Shift Lever Slide Cover Deformation

Section Automatic Transmission/Transaxle

YEAR(S)	MODEL(S)	ADDITIONAL INFORMATION
2013 – 2015	RAV4

Figure 1.

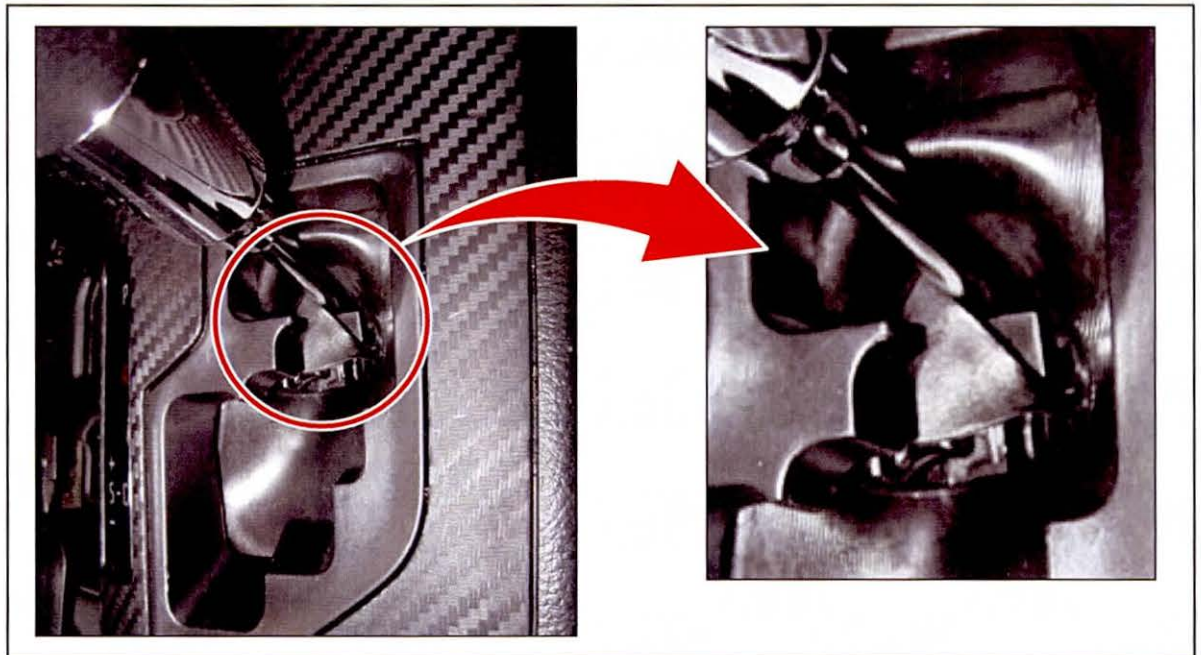
1. Inspect the vehicle for the following conditions:
 - Damaged Slide Cover due to deformation or distortion.
 - Difficult to move shifter due to interference (binding) of the Slide Cover (as shown in Figure 1).

- Remove and replace the Slide Cover, Slide Cover No. 2, and Position Indicator Housing.

Figure 3. Position Indicator Lens

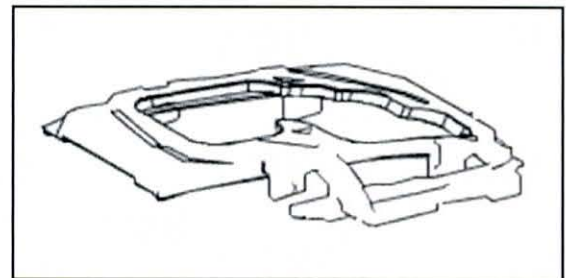
If the Slide Cover housing area has a significant amount of a sticky substance (e.g., soda or juice) after cleaning, it may be necessary to replace the Position Indicator Lens (P/N 35952-0R010, shown in Figure 3) in addition to the parts listed in the Parts Information section.
